GRADING & DRAINAGE PLAN

DATE: LOT 6-A-1, BLOCK 14, FAIRGROUNDS ADDITION  
REVISION: 301 INDIANA STREET, NE ALBUQUERQUE  
A KIPCO PROJECT  
Grading & Drainage Plan

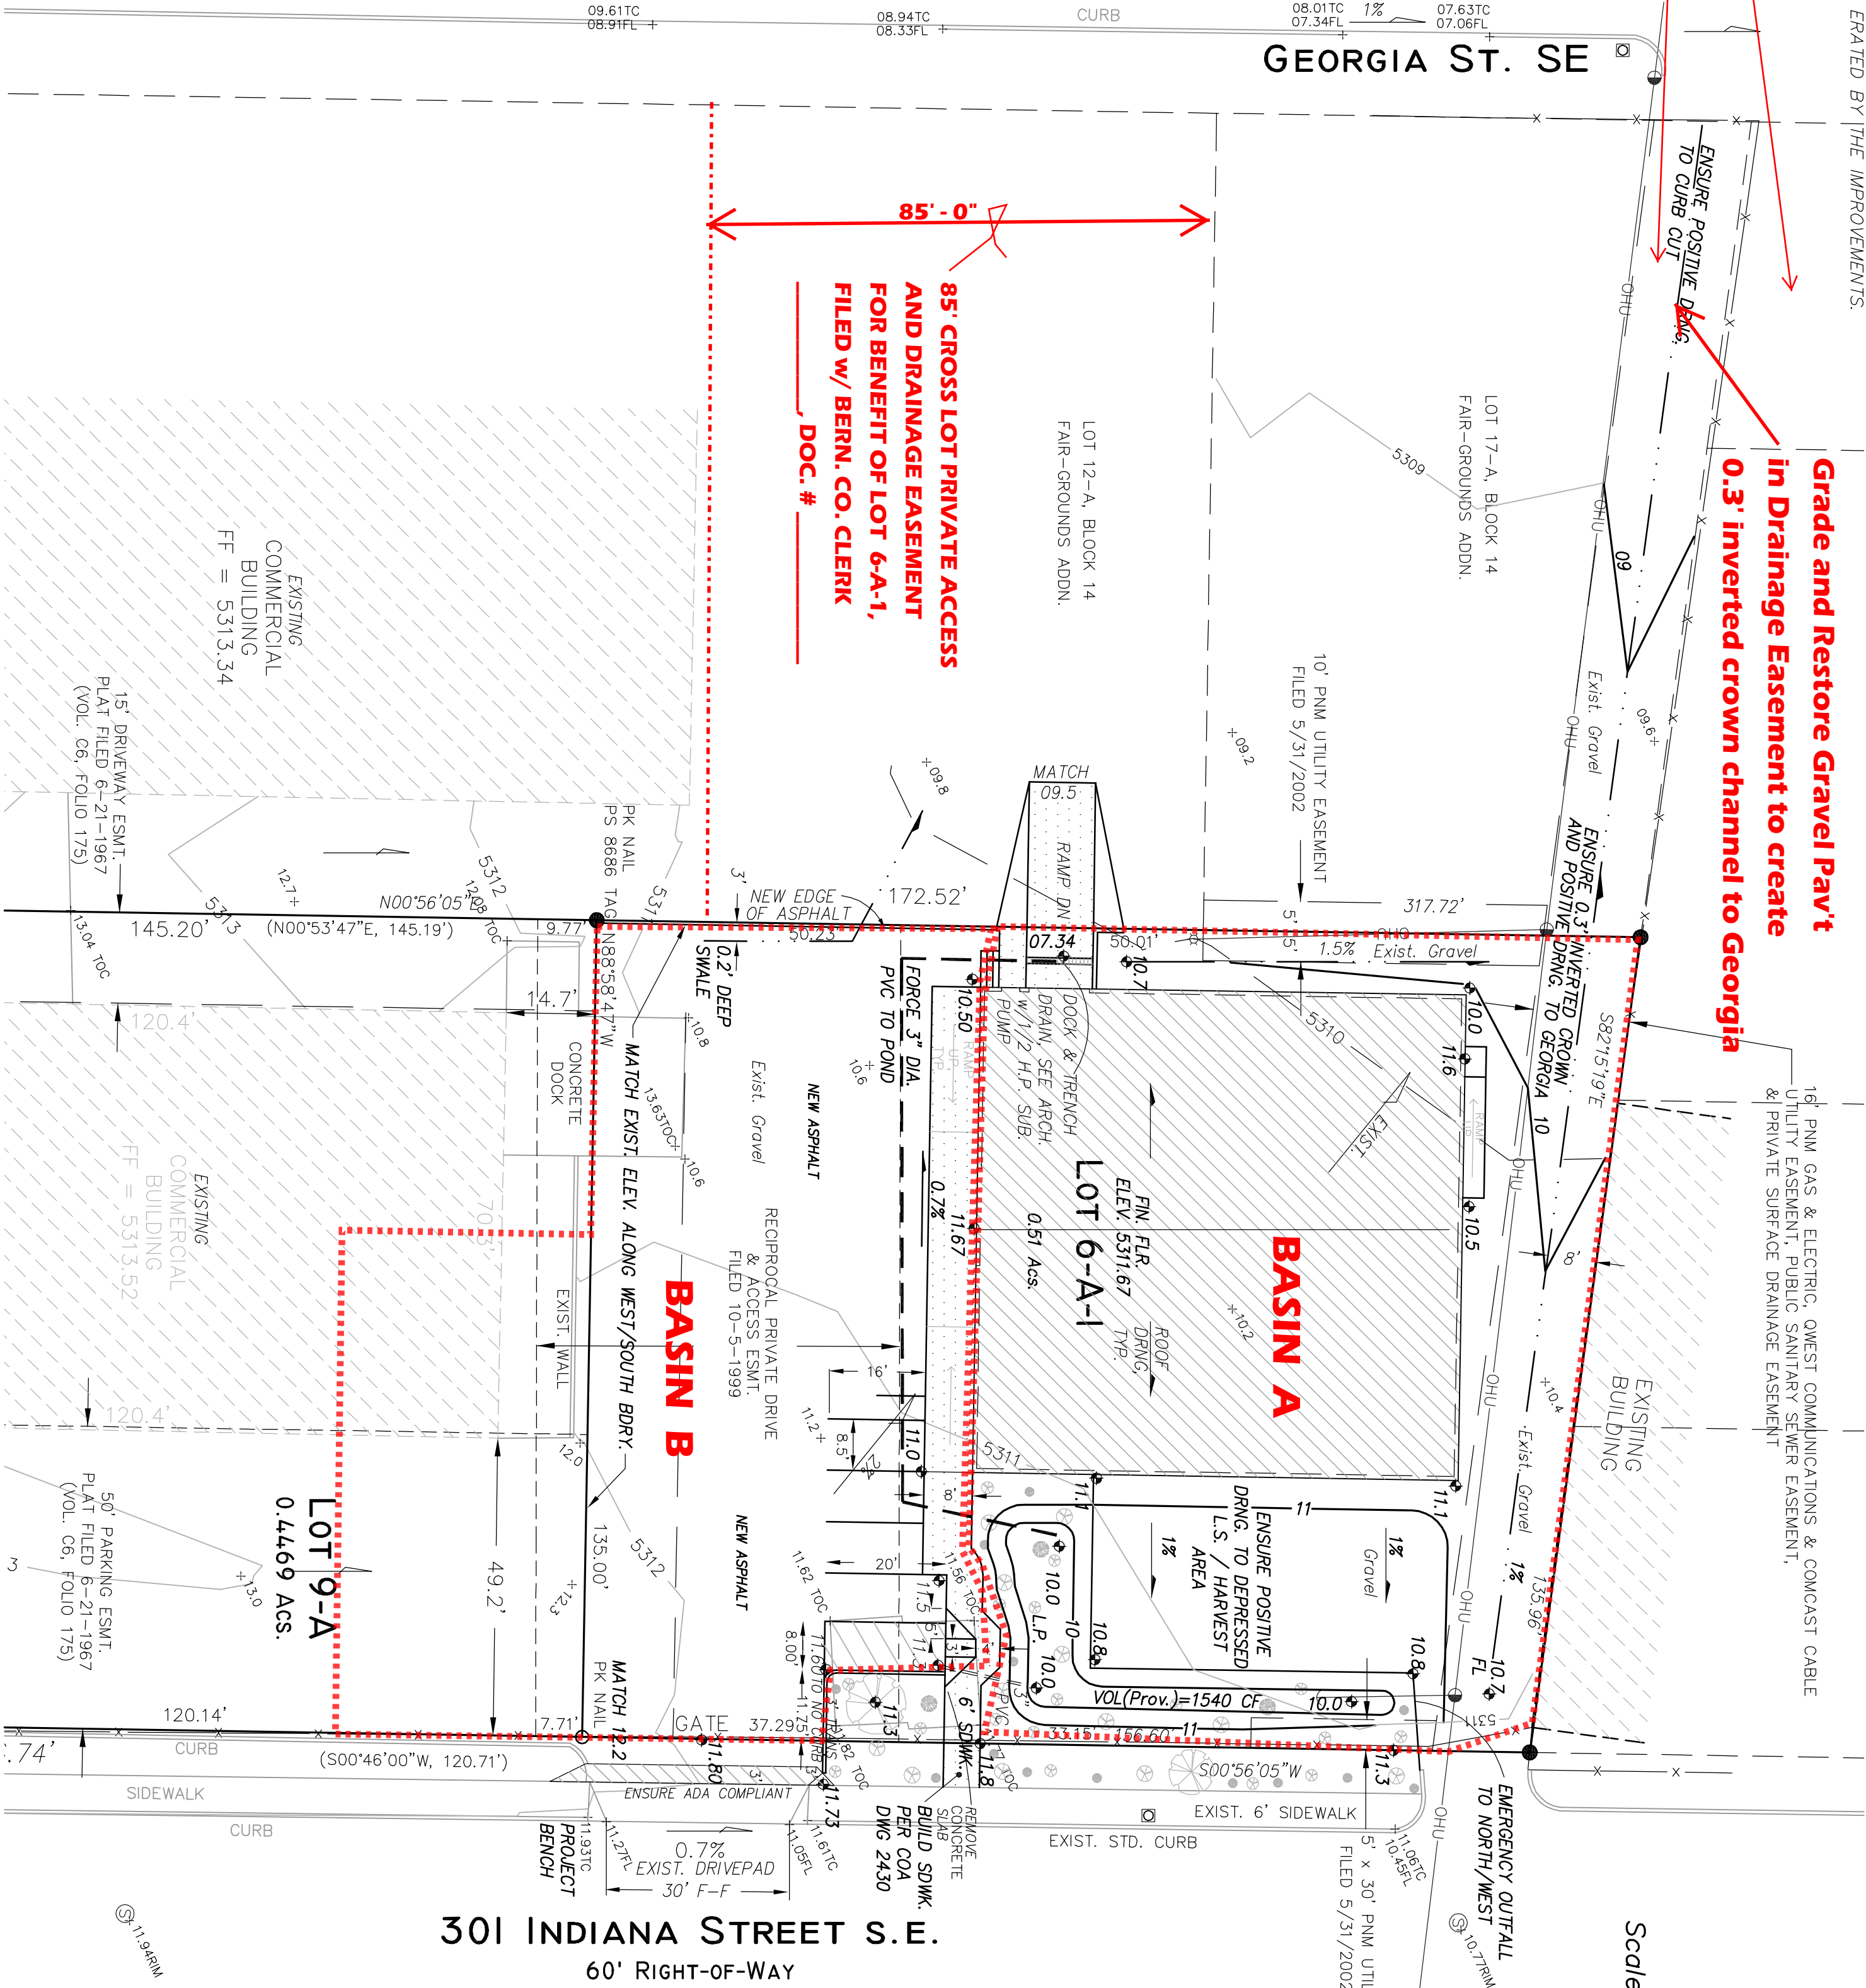
PROVIDE ADDITIONAL SURVEY  
INFO TO CONFIRM THAT FLOWS  
WILL NOT CROSS OVER TO THE  
LOTS NORTH OF THE VACATED  
ALLEY / DRAINAGE EASEMENT

BREAK DOWN DRAINAGE FOR  
THE TWO BASINS, TO ENSURE  
THAT FLOWS DIRECTED TO THE  
NORTHERN DRAINAGE EASEMENT  
WILL REMAIN IN THE 0.3 SWALE
